LIMERICK GENERATING STATION UNITS 1 & 2  
 ENVIRONMENTAL REPORT - OPERATING LICENSE STAGE  
 REVISION 1 PAGE CHANGES

The attached Revision 1 pages, tables, and figures are considered part of a controlled copy of the Limerick Generating Station EROL. This material should be incorporated into the EROL by following the collating instructions below:

FIGURE 7.1-1

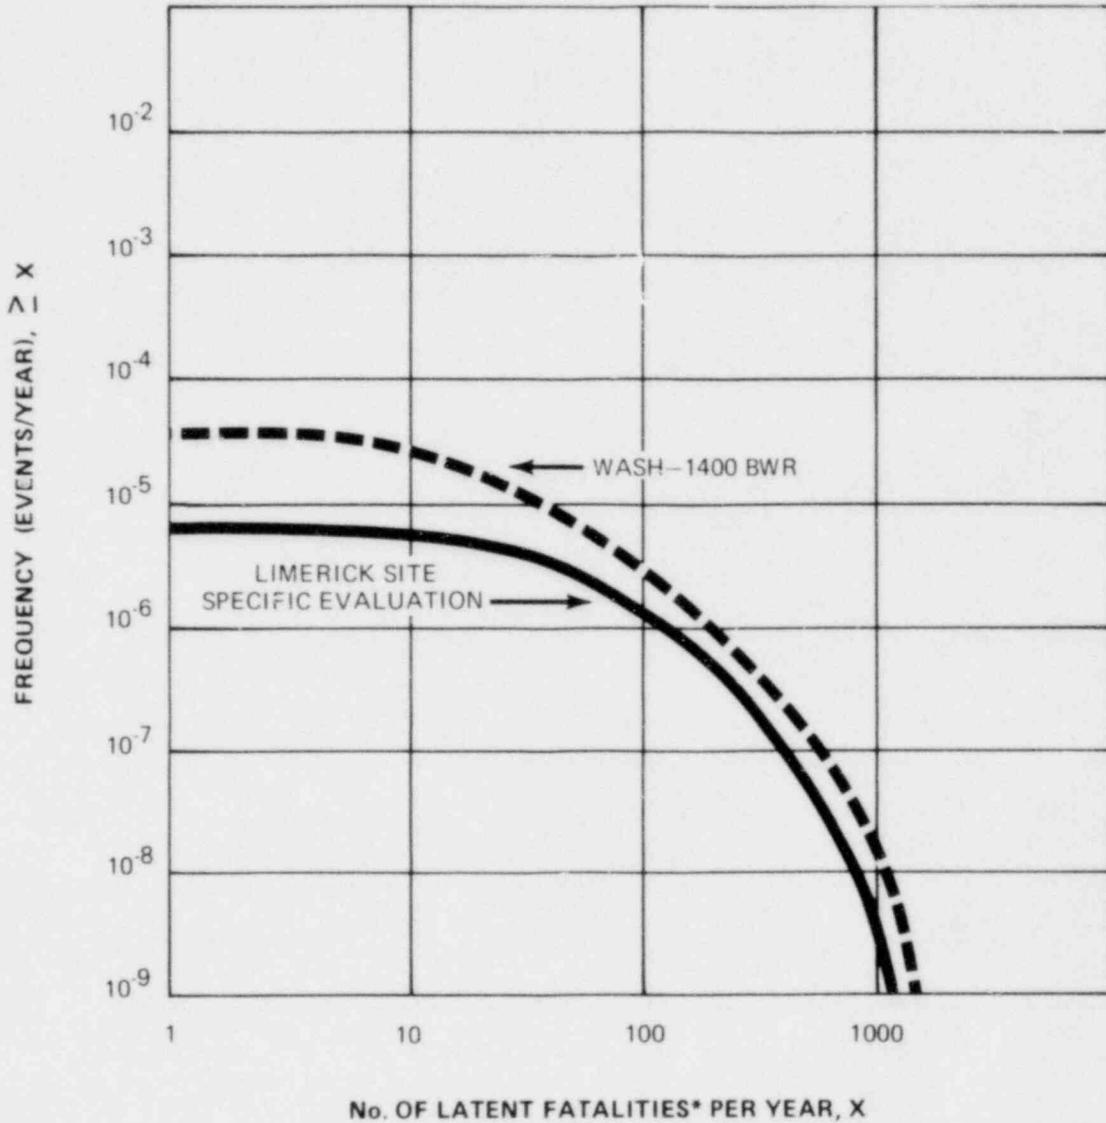
In accordance with NRC's Interim Policy (45FR40101) revise Section 7.1.1 to include a probabilistic evaluation of impacts of accidents including those formerly called Class 9 accidents.

Figure 7.1-1 presents the calculated CCDF for the Limerick site-specific analysis for early fatalities. Also shown in Figure 7.1-1 is the calculated CCDF for the composite site for the WASH-1400 BWR. For comparison, the CCDF curves estimated for total man-caused risk (excluding automobile crashes) and total natural risk to the population around the Limerick site are also plotted in Figure 7.1-1. In addition, the CCDF curve for airplane crashes causing early fatalities to humans on the ground is separated out from the total man-caused risk and presented. This component has been specifically included as an example of the risk to which the population is subjected without conscious decision.
